DREAMY DRAW DAM

PERIODIC INSPECTION

REPORT NO.1

SUBJECT: Periodic Inspection and Continuing Report No. 1 - Dreamy Draw Dam

LOOKING AT DISTURBED SETTLEMENT MONUMENT.
NOTE WHEEL TRACK IN SHADOW AT THE BASE OF
THE PIPE.

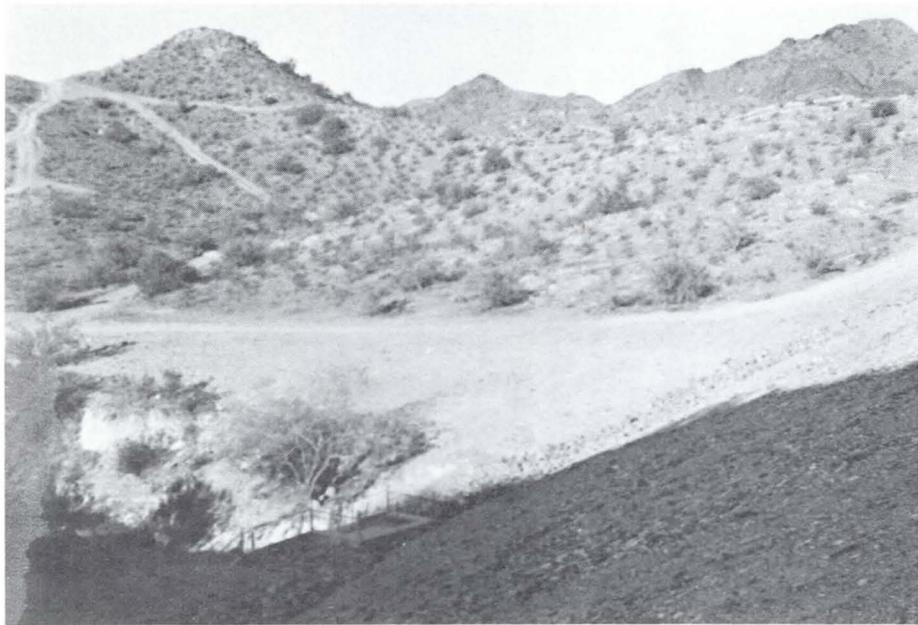
- (1) Recorder - A battery operated, hydro-gage driven Stevens A-35 recorder has been installed in the recorder house. The recorder will operate 24 hours a day. Batteries will be replaced every six months.
- (2) Recorder house - Vandals had destroyed the 3 inch concrete roof overhang on two sides of the roof. In addition several holes had been knocked in the outer skin of the metal door, and the latch had been partially destroyed.
- (3) Settlement monuments - Five settlement monuments and two reference monuments were surveyed on 17 January 1974. One reference

monument had been destroyed, and several settlement monuments displayed signs of having been disturbed. It was noted that one of the monuments had been pushed off line and grade. Six 3-inch x 8-inch x 6-foot guard posts had been pulled out and thrown on the upstream slope of the embankment.

d. Reset monuments so that protective caps are 3-inches below the surface. Resurvey and reference location of all monuments.
